R0083 - CHANGES TO SUPPLY NUMBER FORMAT FOR MHHS - GUIDANCE

This document provides guidance for population of the Supply Number, for MHHS Metering Points and non-MHHS Metering Points, following implementation of R0083.

The Supply Number format:

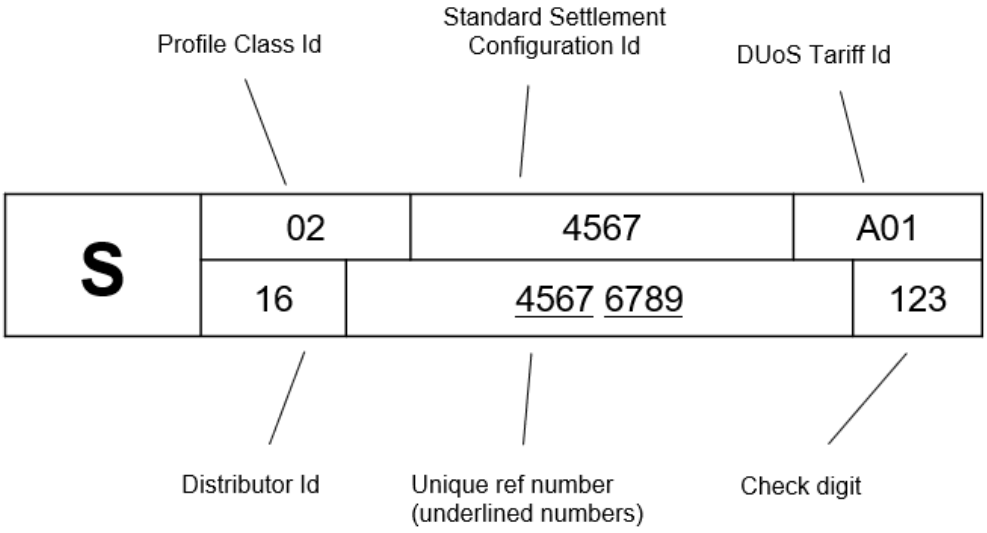
The new format:

- Retains the Profile Class Id
- Replaces Meter Timeswitch Code (MTC) with Standard Settlement Configuration (SSC) Id
- Replaces Line Loss Factor Configuration (LLFC) Id with DUoS Tariff Id

DATA ITEM	GUIDANCE
Profile Class Id	Populate from existing Profile Class valid set
SSC Id	Populate from the SSC Id valid set
DUoS Tariff Id	Populate from the LLFC Id valid set
Bottom line Data Items	Continue as currently

DATA ITEM	GUIDANCE
Profile Class Id	Populate with a value between 01 and 08 for Traditional Meters and, where required for Smart and Advanced meters. Populate with '00' for any Metering Points that do not have a Profile Class
SSC Id	Populate from the SSC Id valid set for Traditional Meters and where required for Smart and Advanced meters Populate with '0000' for any Metering Points for which the SSC Id is not applicable
DUoS Tariff Id	Populate from the DUoS Id valid set - this is the same as the LLFC Id valid set
Bottom line Data Items	Continue as currently
